**Kenmore Town Green
Addendum No. 3
Sept 18, 2015**

KENMORE TOWN GREEN
6728 NE 181ST ST.
KENMORE, WA 98028

**Re: Kenmore Town Green
Questions & Answers**

SHEET TITLE:
EXTERIOR DETAILS

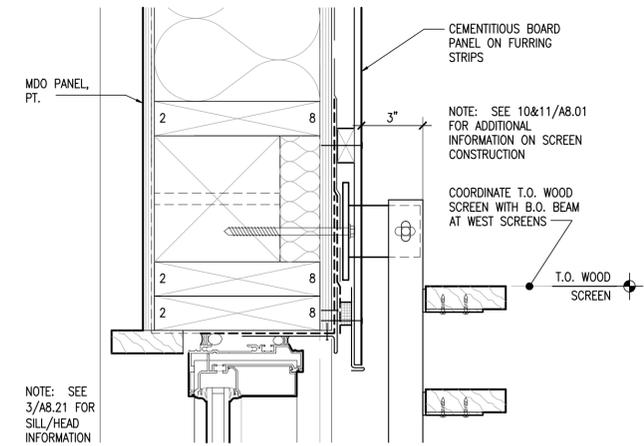
Project Manual Revisions		
Item	Document	Description of Change
Addendum 03 – 1	06 12 00 Structural Insulated Panels	See revisions.
Addendum 03 – 2	07 41 13 Metal Roof Panels	See revisions.
Item	Document	Description of Change
Addendum 03 – 3	A8.01	Change callout from motorized shades to manual roller shades.
Addendum 03 – 4	C4.00	Revised channelization for 68 th Ave NE
Item	Substitutions	Description
Addendum 03 – 5a	08 71 00 Door Hardware	Stanley Security Solutions.: Locksets & Cylinders. Substitution Approved.
Addendum 03 – 5b	08 71 00 Door Hardware	Stanley Security Solutions.: Hinges. Substitution Approved.
Addendum 03 – 5c	08 71 00 Door Hardware	Stanley Security Solutions: Exit Devices. Substitution Approved.
Addendum 03 – 5d	08 71 00 Door Hardware	Stanley Security Solutions: Door Closures. Substitution Approved.

NO.	DESCRIPTION	BY	DATE
1	Text of call-out changed	RE	09/11/15

SHEET TITLE:
**RIGHT-OF-WAY
PAVEMENT
RESTORATION PLAN**

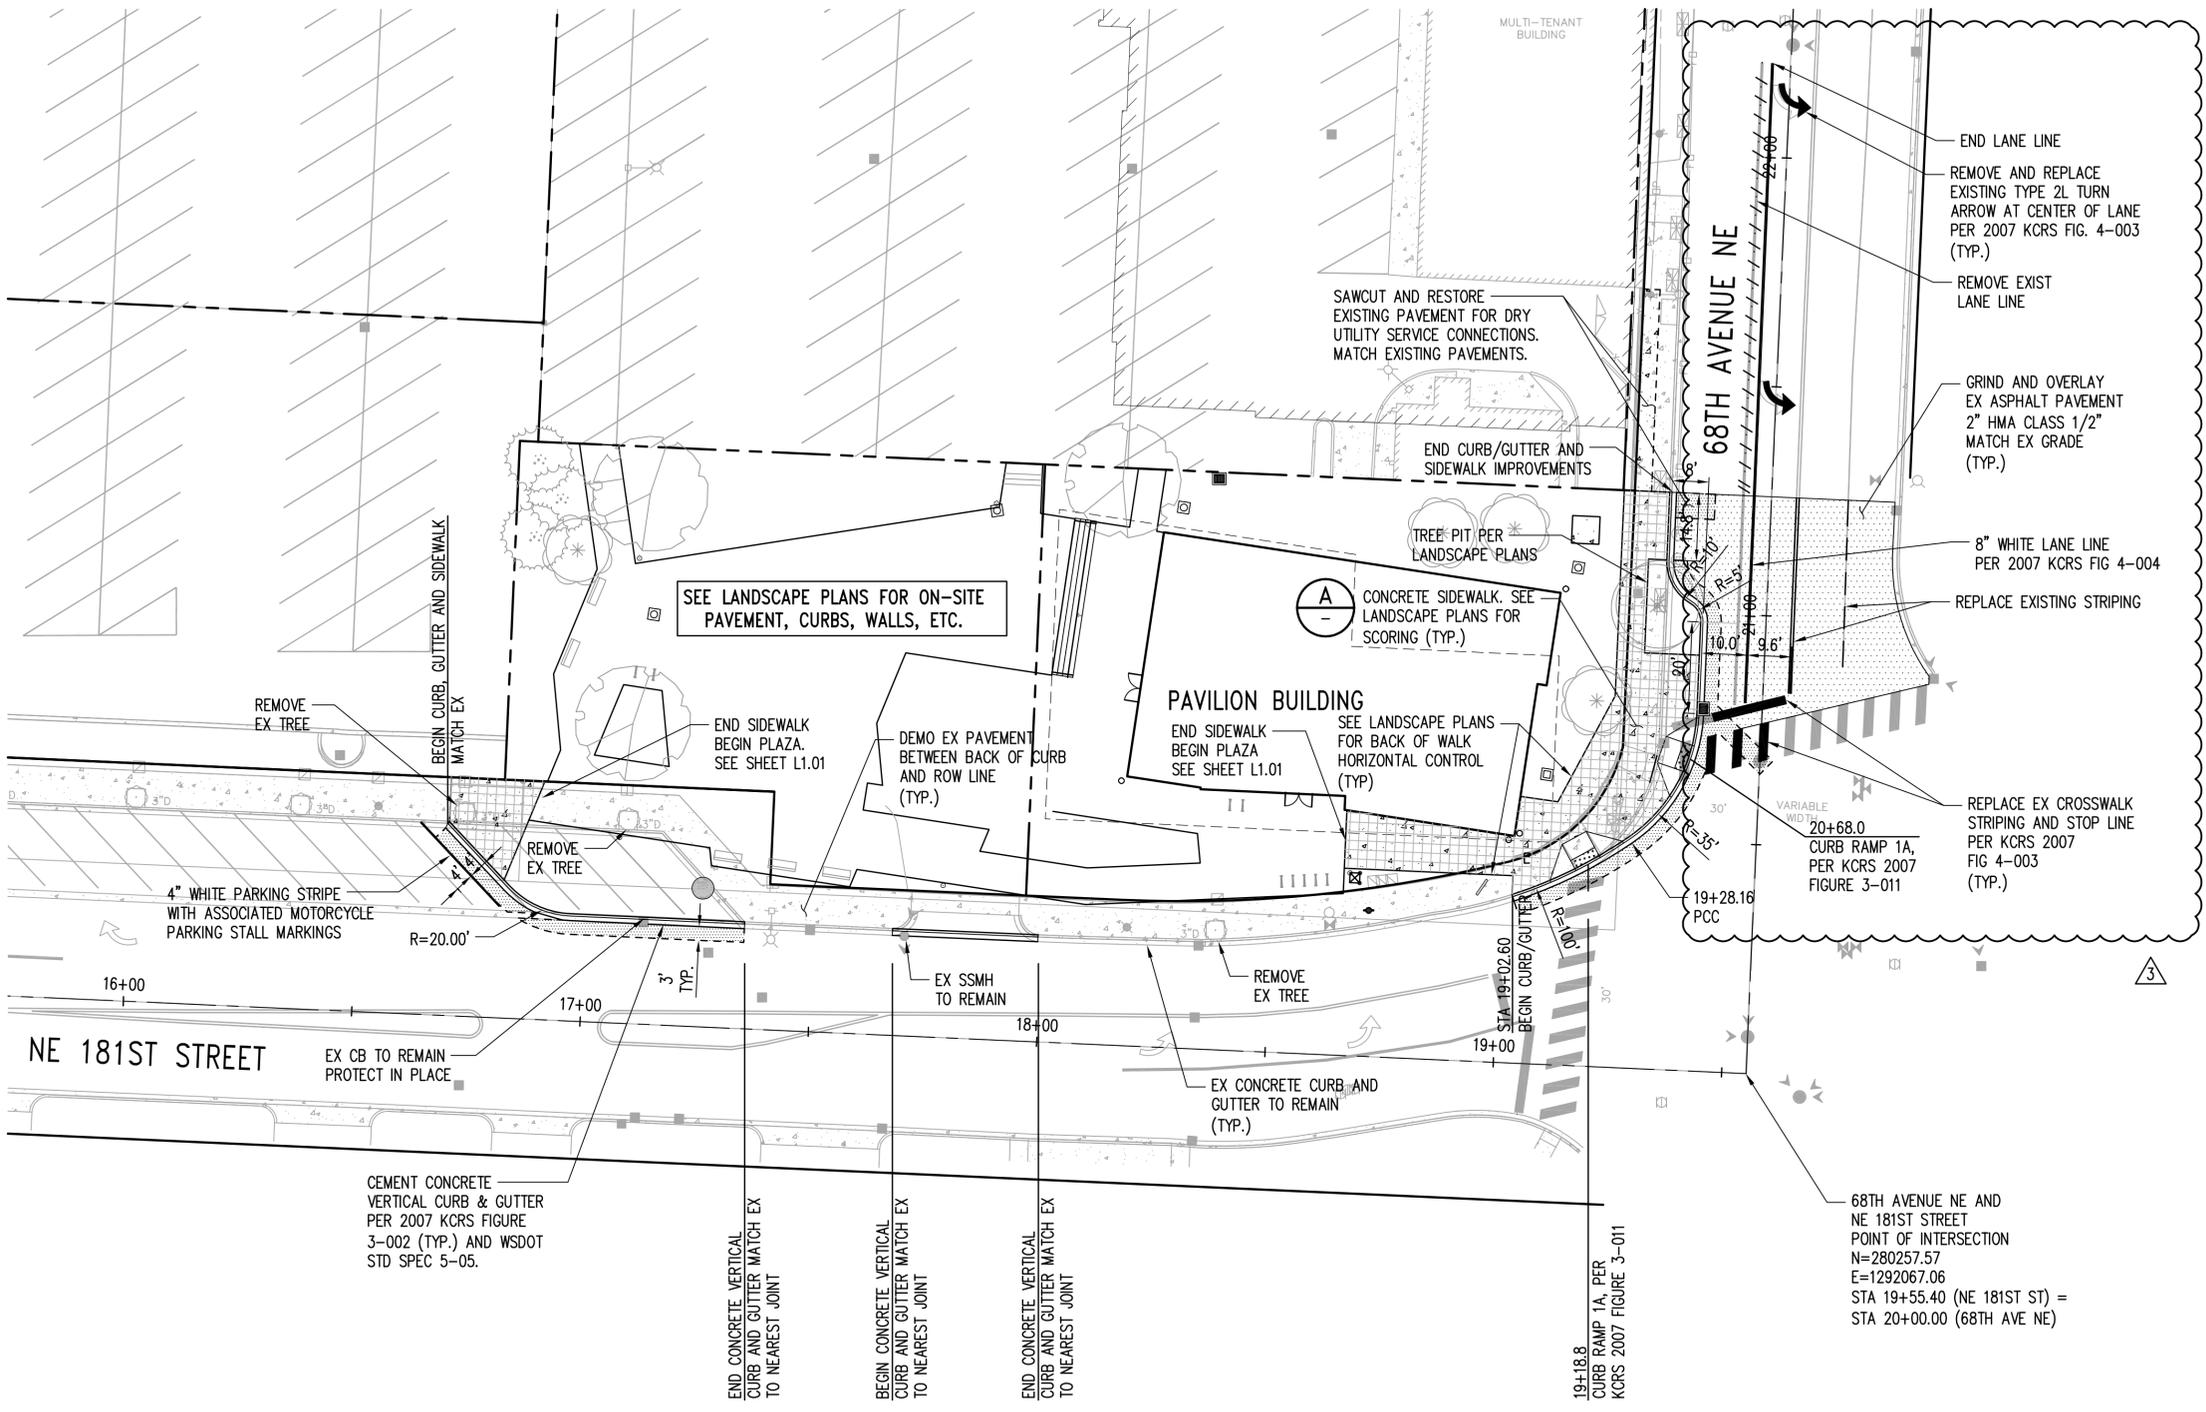
NO.	DESCRIPTION	BY	DATE
1	BID ADDENDUM 1	KPFF	9/4/2015
3	BID ADDENDUM 3	KPFF	9/21/2015
